1959 Corvette: Service Bulletin: Excessive Driveline Vibration

Subject: Excessive Drive Line Vibration

Source: General Motors of Canada Service Bulletin

Date: September 30, 1959

The propeller shaft and pinion angle and the elongation of the radius rod mounting bracket hole is shown in Fig. 44.

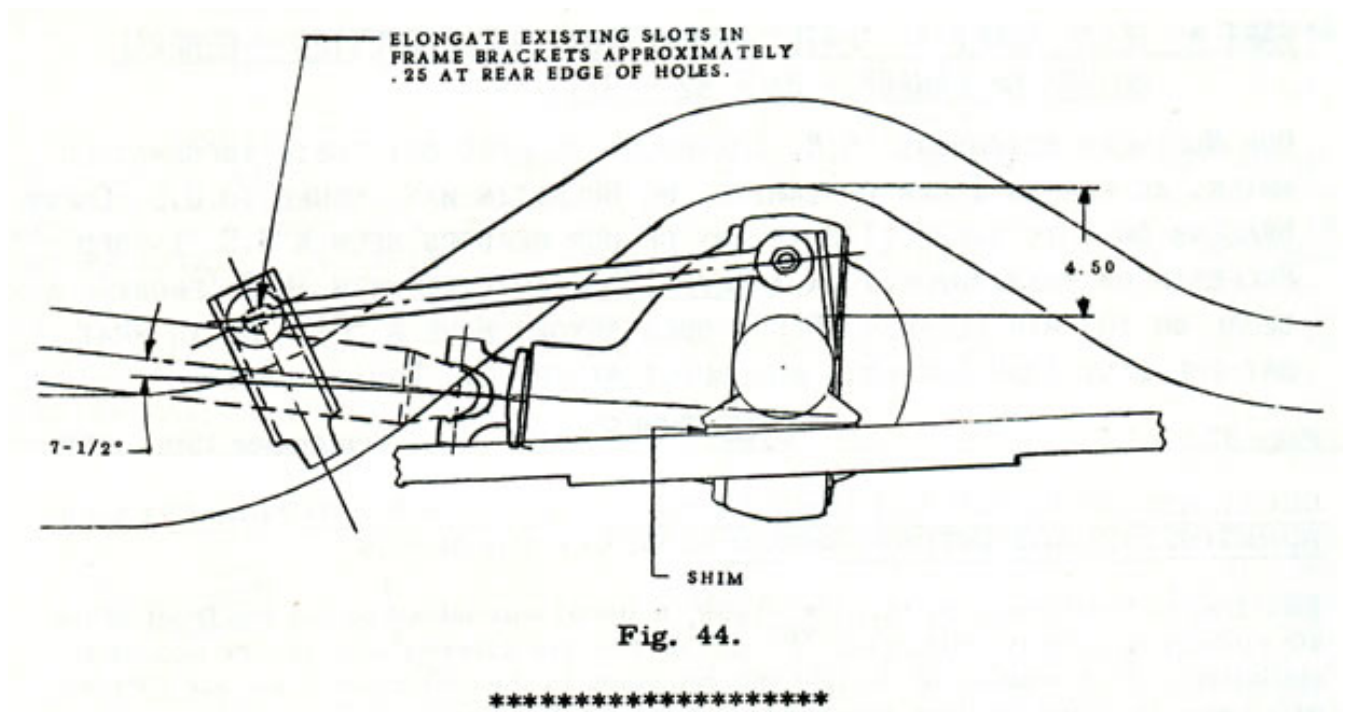
If excessive drive line vibration is encountered on the 1959 Corvette, it is probably due to excessive rear U-joint angle. Elimination of the vibration can be accomplished by installing either a 2° or 3° shim between the axle pads and springs on both sides, with the thick side to the front.

The nominal angle of the rear U-joint is 7-1/2°. Care should be taken in not going under 7-1/2° due to interference at full bump position.

1. Load vehicle until distance between the axle housing and the frame rail kick (metal to metal) is 4-1/2". Retaining the vehicle in this position, the angle of the propeller shaft and pinion nose can be measured, as shown in the 1958 Passenger Car Shop manual.

2. The radius control rods should be disconnected before installing the shim. Before re-attaching the radius control rods, elongate the radius rod frame mounting hole 1/4" rearward if necessary to eliminate any interference between the radius control rods attaching bolt and mounting bracket. Shim part #3722797 (2 °), or #3744488 (3 °), or their equivalent may be utilized. The locating tab on the above shims should be removed to allow the shim to lie flat.
